ADDENDUM - 01

ADDENDUM #1

AUDITORIUM RENOVATION – F.W. HOLBEIN
SCHOOL

RYEB Project #5733A

COVER SHEET

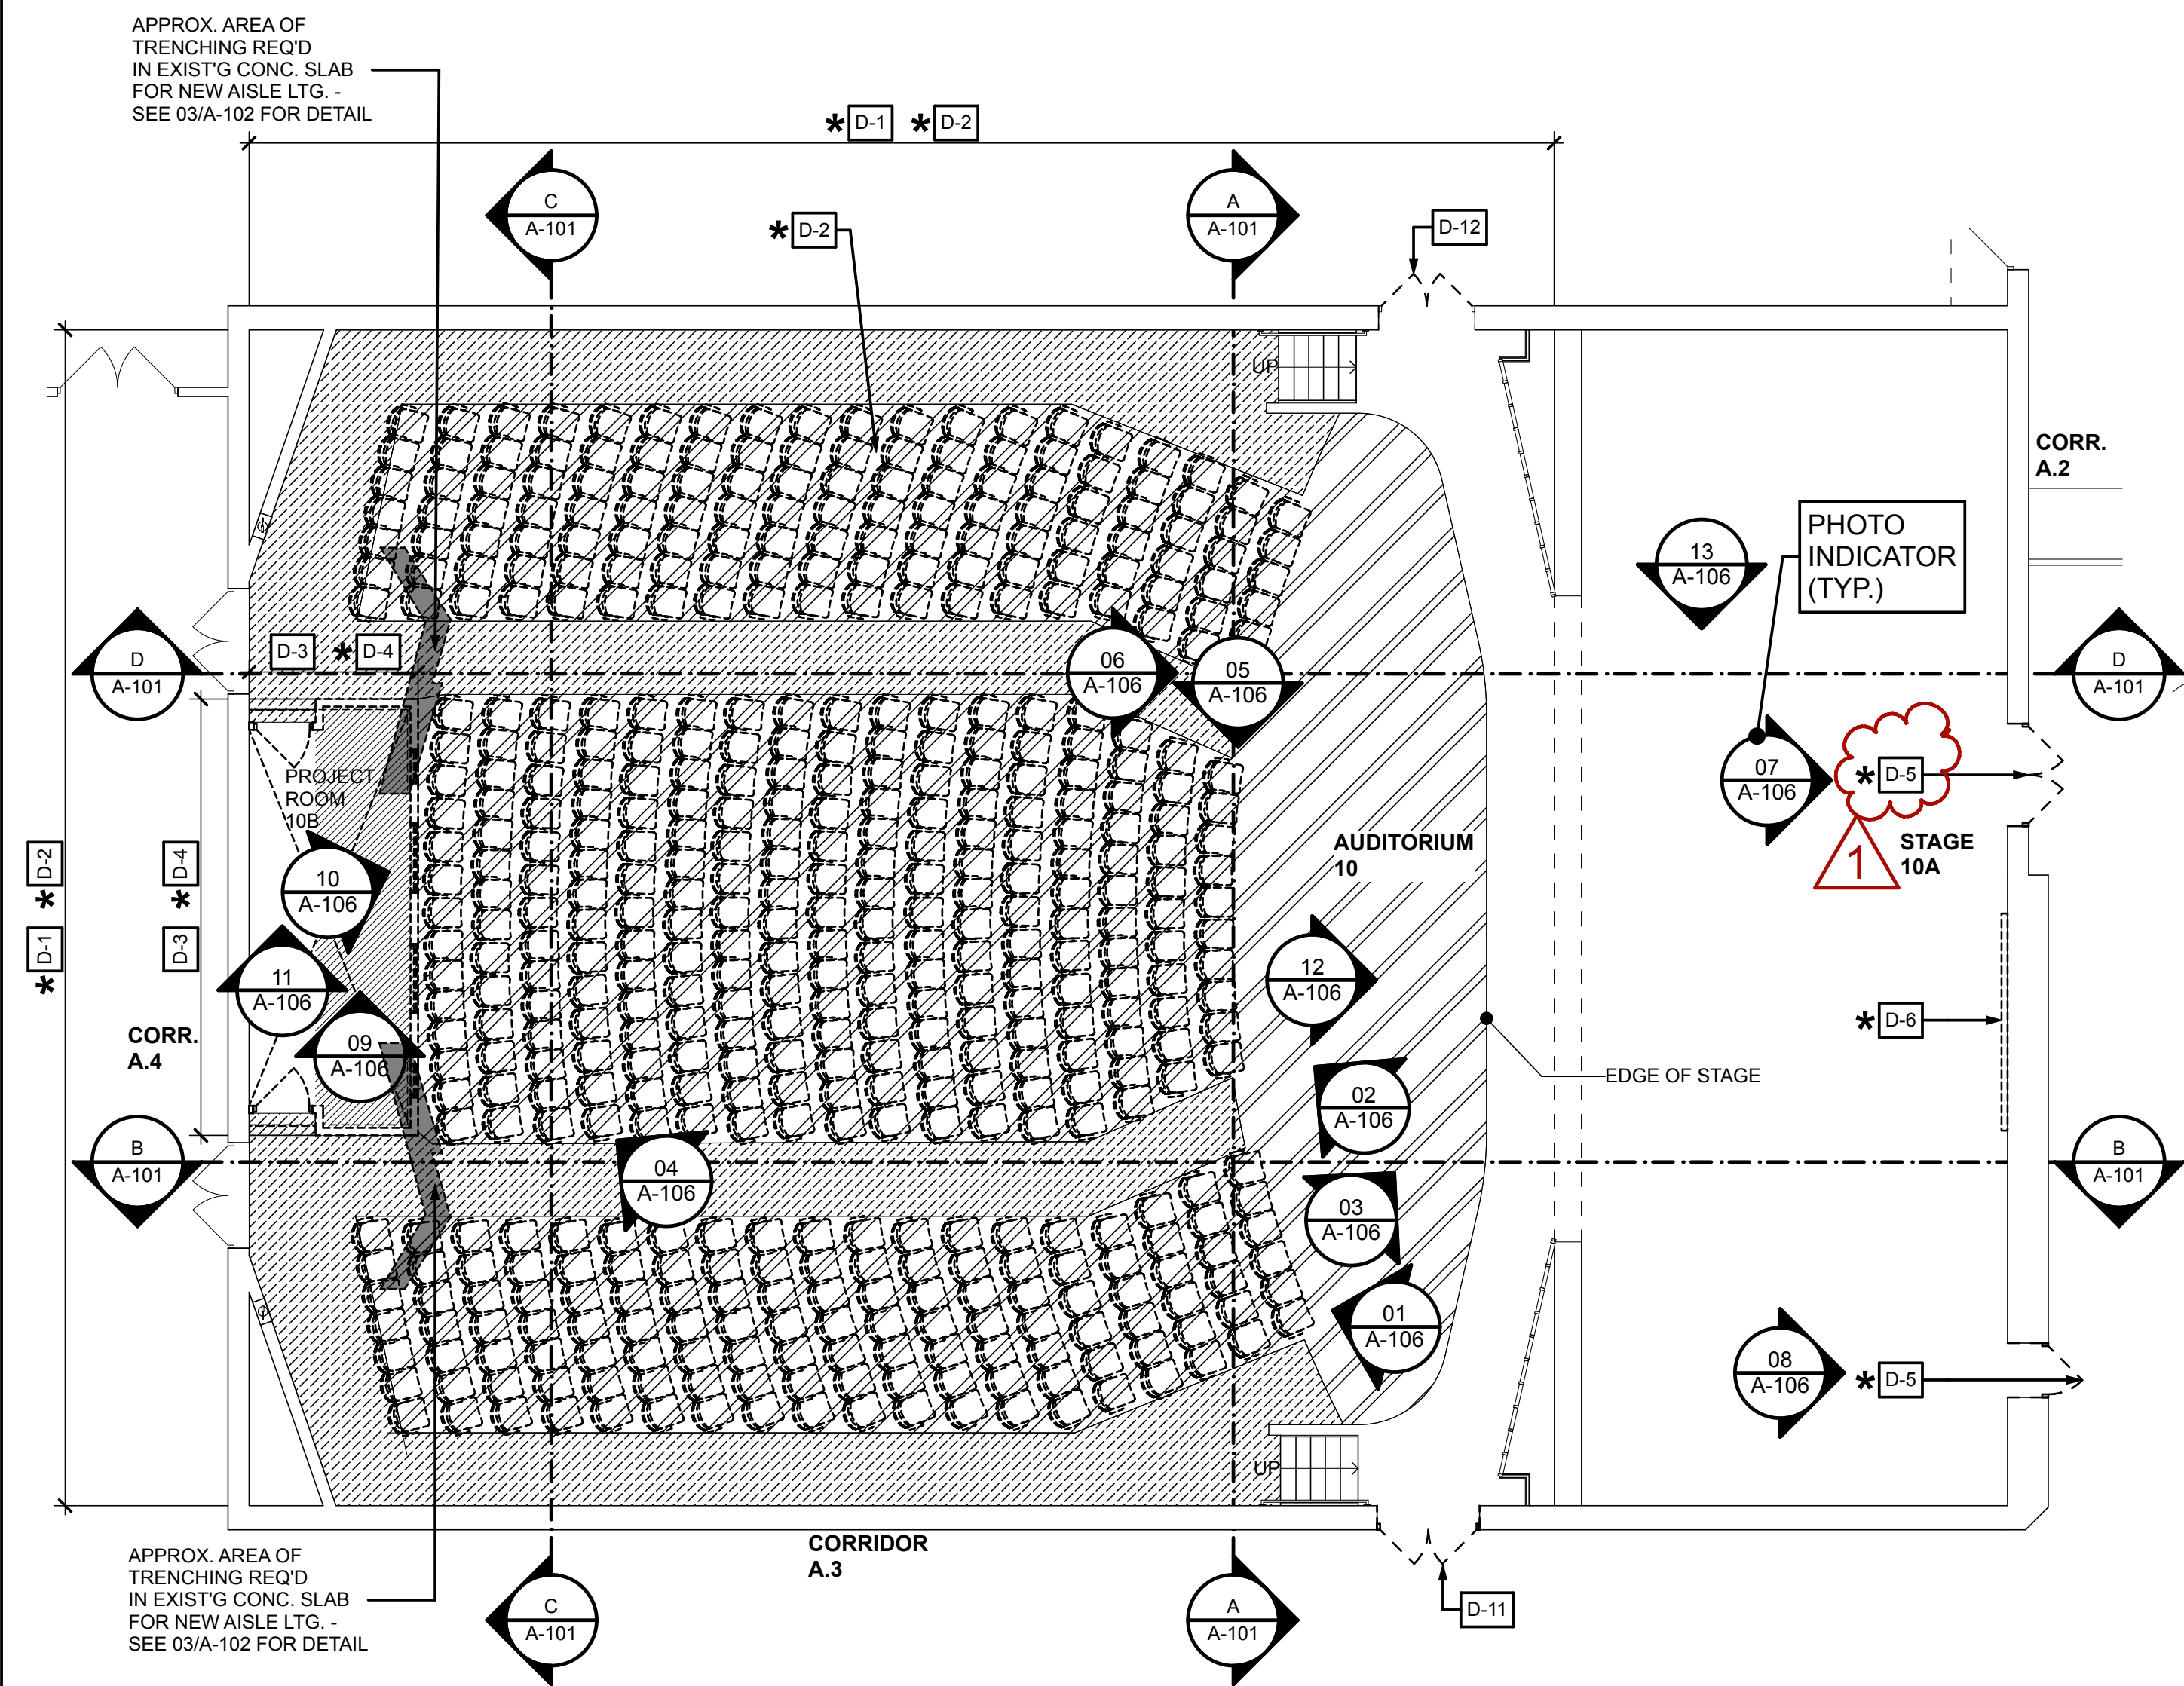
1.04 **AMENDMENT:** (Reference to Section 028213, Removal and Disposal of Asbestos Containing Materials & Drawing HA1.01): The Contractor shall be permitted to conduct the asbestos abatement work during the District's Spring Break, which will take place from 03/29/2024 through 04/07/2024. The work shall be limited to the existing seating and flooring system abatement only. The removal of the doors and frames and other asbestos related work shall occur over the summer construction schedule.

ELECTRICAL AND LIGHTING NEW WORK PLAN

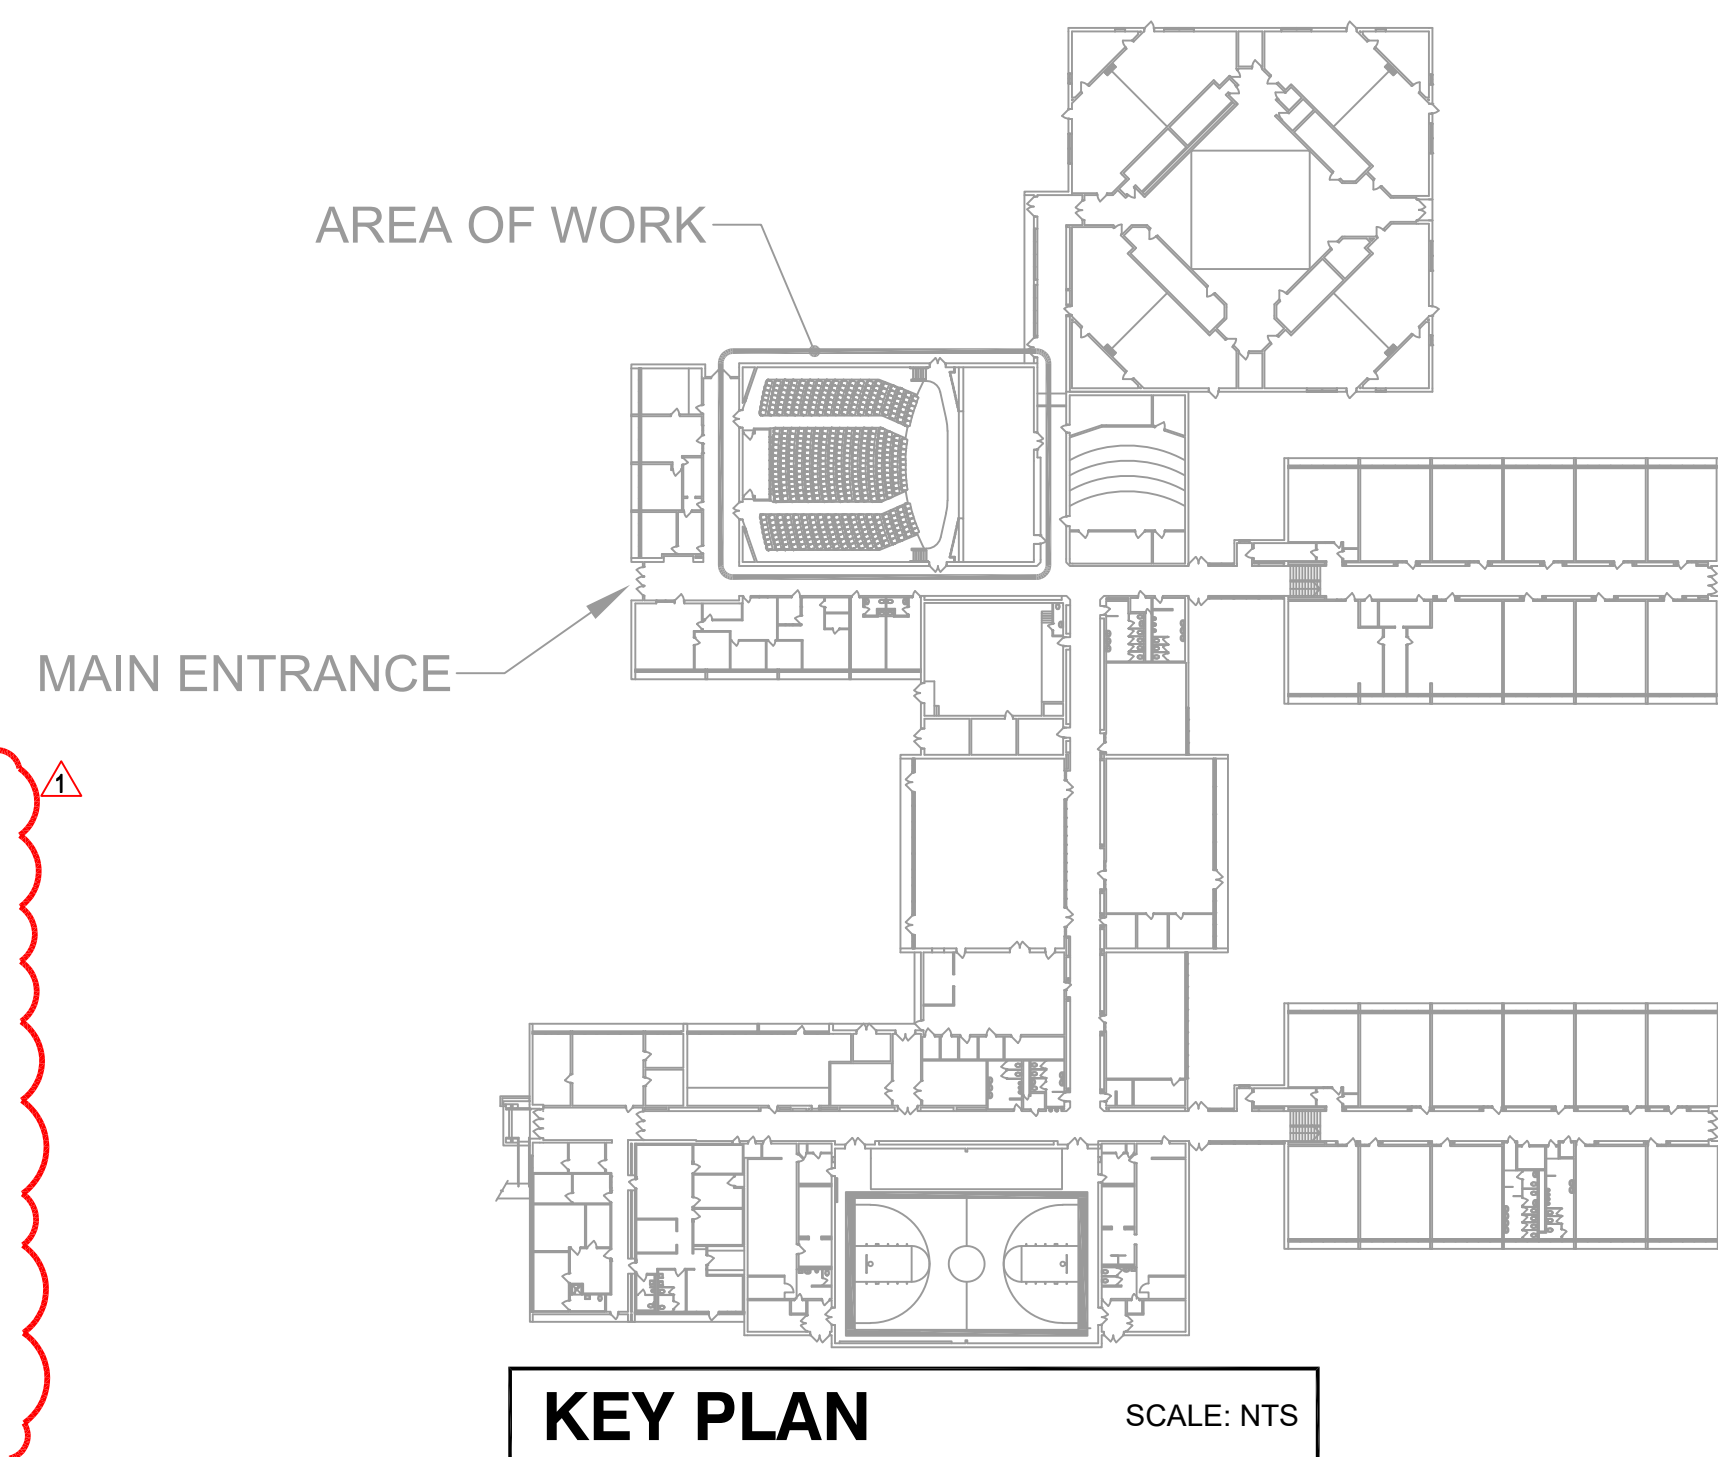
1.10 **AMENDMENT:** The contractor shall provide one (1) Network GPIO Expander, QSC part number QIO-GP8x8, as part of the Audio-Visual Bill of Materials on Dwg E-200. This equipment shall be utilized to perform the muting of the auditorium sound system in the event of fire alarm system relay activation or a panic alarm system relay activation. Contractor shall provide all necessary wiring, all required supporting equipment/components, and programming to accommodate this sequence of operations.
